Staff Report Template – Site Plan Review for Commercial or Industrial Development

FENCE SITE PLAN REVIEW
SQ-23-15
ON SITE IMPROVEMENTS
2000 QUEEN AVENUE SE
ALBANY, OR 97322

The proposal is an application Site Plan Review – Minor Development to construct a fence and electronic gates with associated changes to site circulation at 2000 Queen Avenue SE. The subject site is Parcel 1 of an approved tentative partition plat and is 3.30-acres in size and located in the Community Commercial (CC) zoning district.

Sheet **C100**
SCALE: SEE BARSCALE

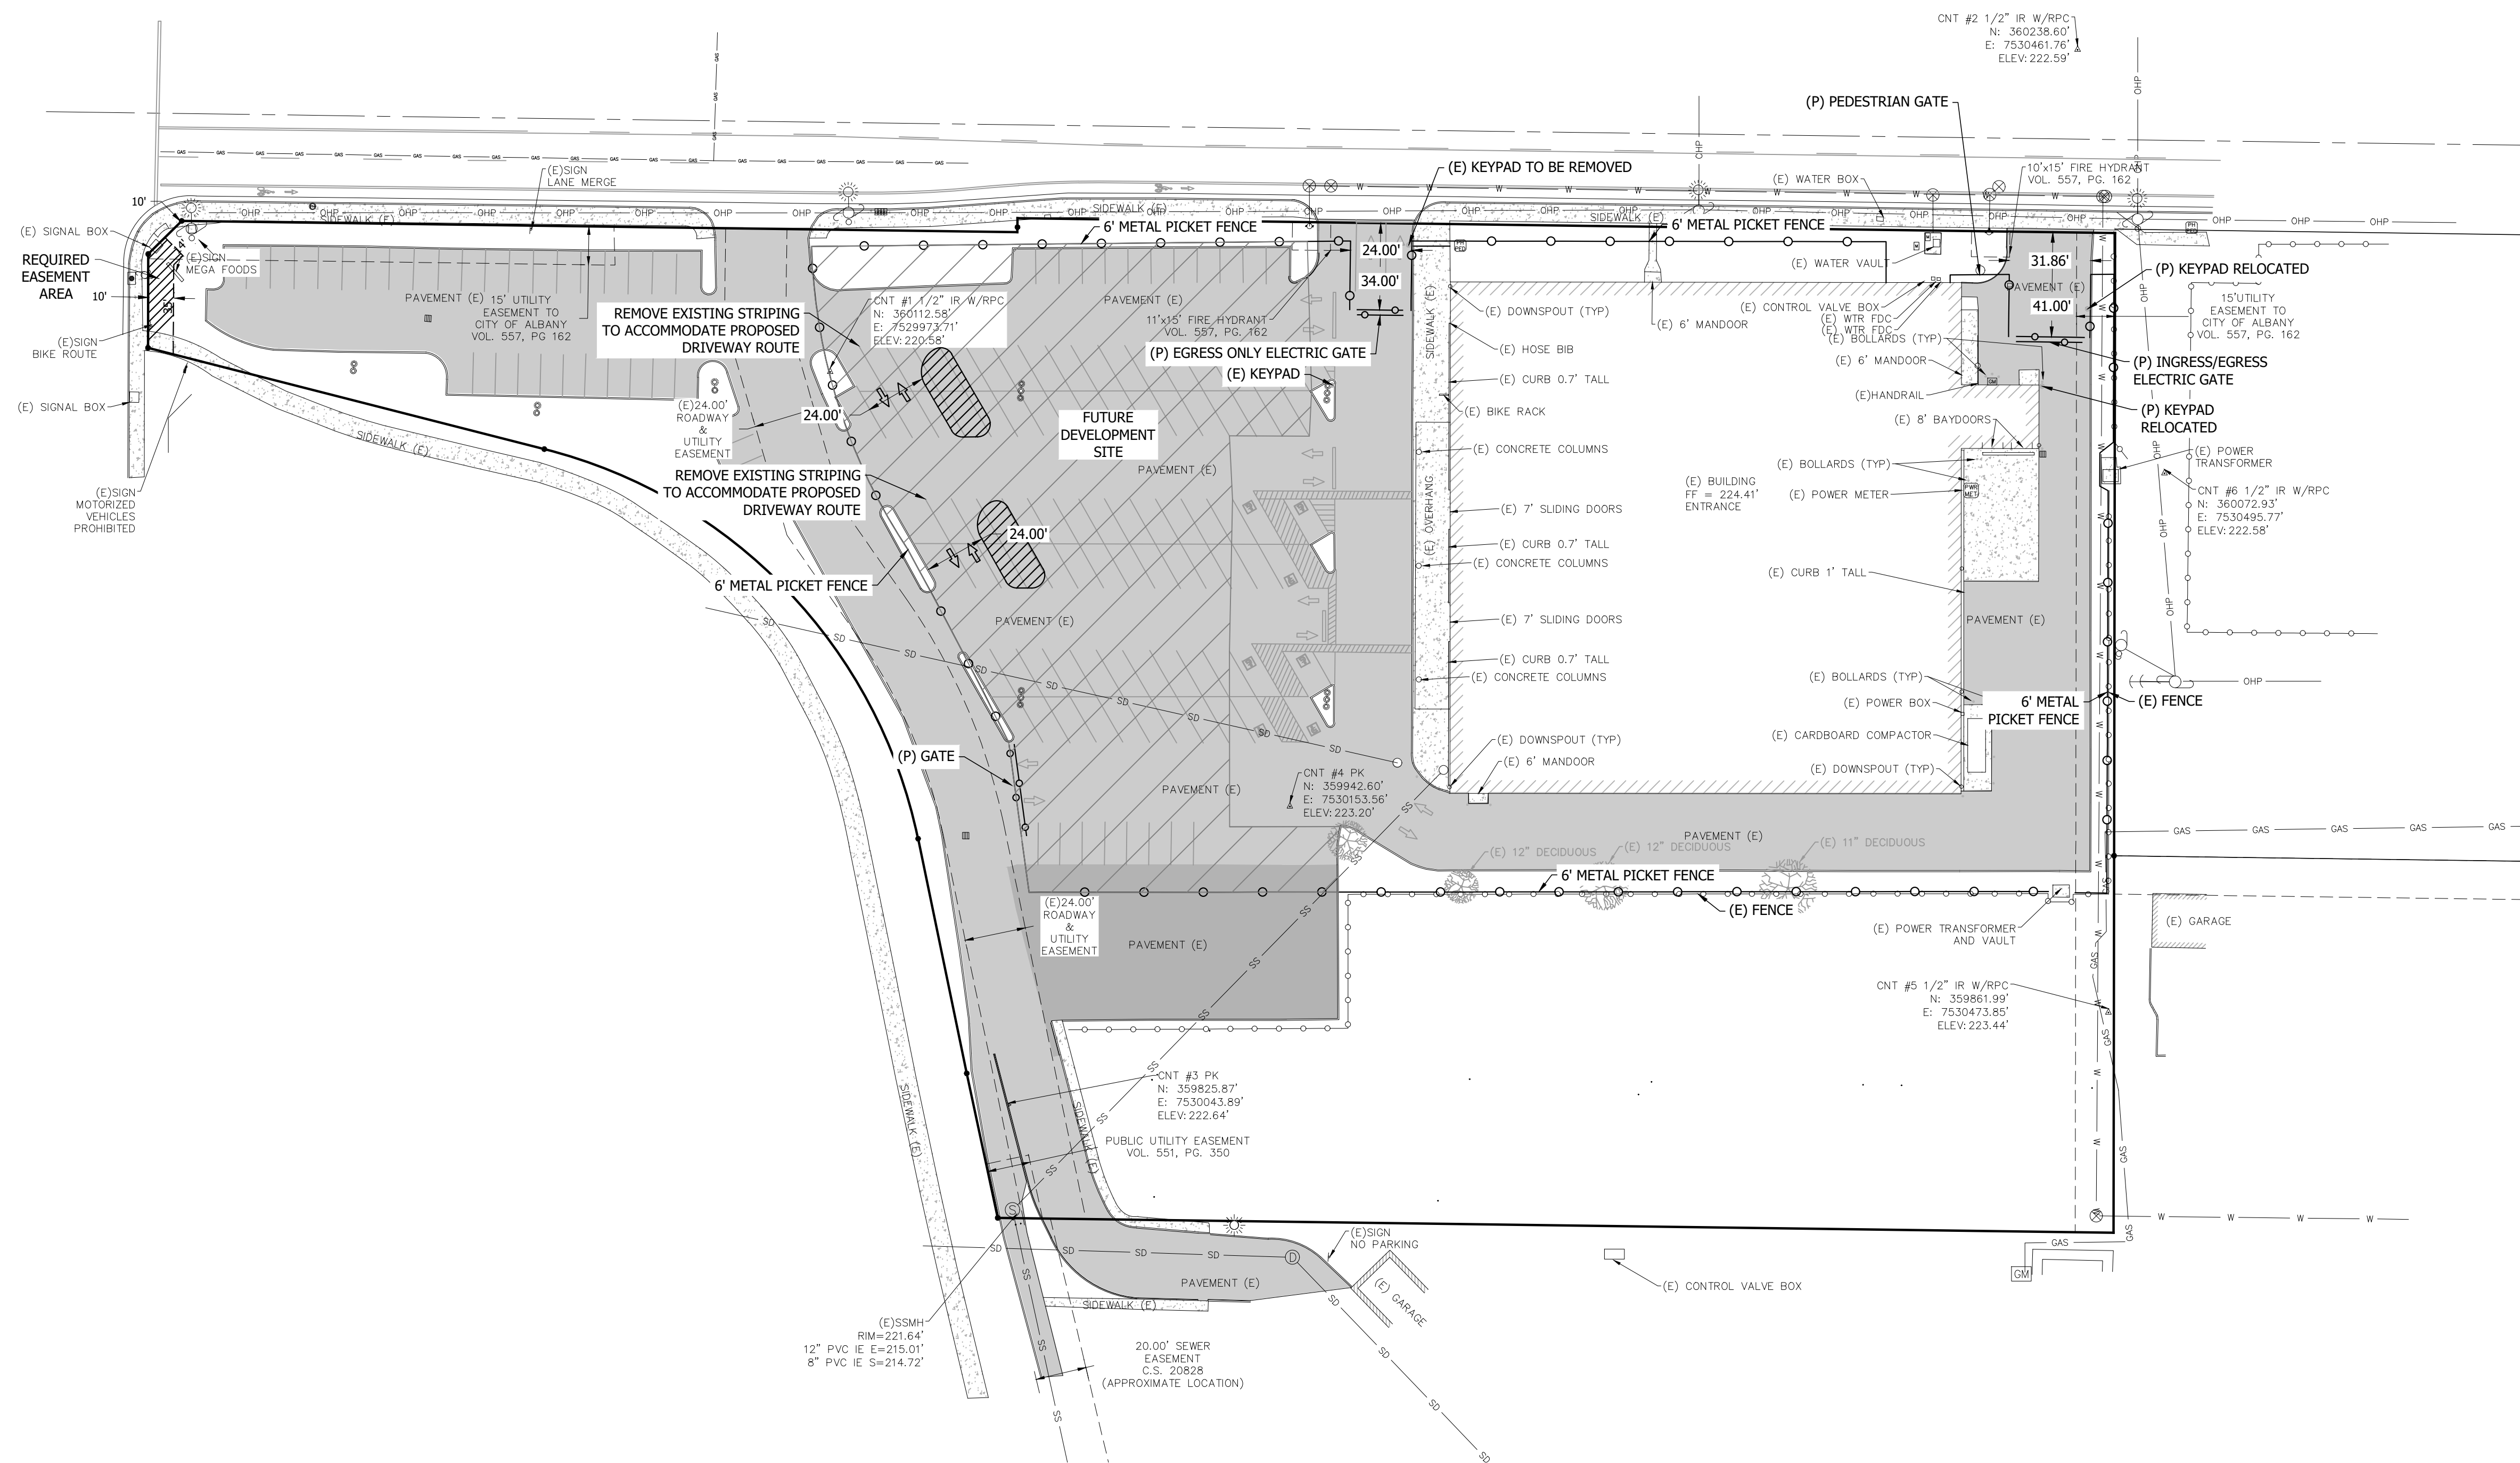
8.7: The site's west driveway will remain fully open with no modification of allowable movements.		PM Peak Hr. Trips _____	
8.8: The site's middle driveway will be limited to egress only movements and will have an electric gate installed approximately 24 feet behind the back of the sidewalk. Because the driveway will be		See findings at left <input checked="" type="checkbox"/>

<p>limited to exiting movements, a "Exit Only – Do Not Enter" sign is needed along Queen Avenue to help keep entering drivers from attempting to use approach.</p> <p>8.9: The site's east driveway will allow for both ingress and egress movements. An electric gate will be installed approximately 41 feet behind the back of sidewalk. The distance between the gate and sidewalk will help prevent entering vehicles stopped to operate the gate from blocking the sidewalk.</p> <p>8.10: The development is not projected to generate additional vehicle trips or result in related impacts to the transportation system.</p>	
Conditions	
Condition 4: The applicant shall install a "Exit Only – Do Not Enter" sign at the site's middle driveway to Queen Avenue.

2.2: The applicant proposes access to two of the existing driveways via a gate accessible by keypad. The location of the easternmost access gate is 41 feet from Queen Avenue SE, which is long enough to accommodate most passenger vehicles and small moving trucks.

2.3: Pedestrian access is provided from the building to Queen Avenue via an existing sidewalk to the east of the middle driveway. The applicant proposes to provide a secondary pedestrian access between Queen Avenue and the existing building along the western side of the easternmost driveway.
Conditions
None.

8. Gates securing access to the private fire apparatus access roads required for this project shall comply with all of the following criteria (OFC D103.5):

At each electric gate, provide a 3200 series Knox Box. We will place a code specific for the fire department inside.

- Condition 1* Prior to the final building inspection, a 5-foot-wide sidewalk from Queen Avenue to the front access shall be constructed at the easternmost driveway.
- Condition 2* All required landscaping must be installed or have landscaping guaranteed in accordance with ADC 9.190 prior to Certificate of Occupancy.
- Condition 3* The applicant shall either install an irrigation system or submit a letter from a qualified landscape professional stating that irrigation is not required per ADC 9.165 prior to the Certificate of Occupancy.
- Condition 4* The applicant shall install a “Exit Only – Do Not Enter” sign at the site’s middle driveway to Queen Avenue.
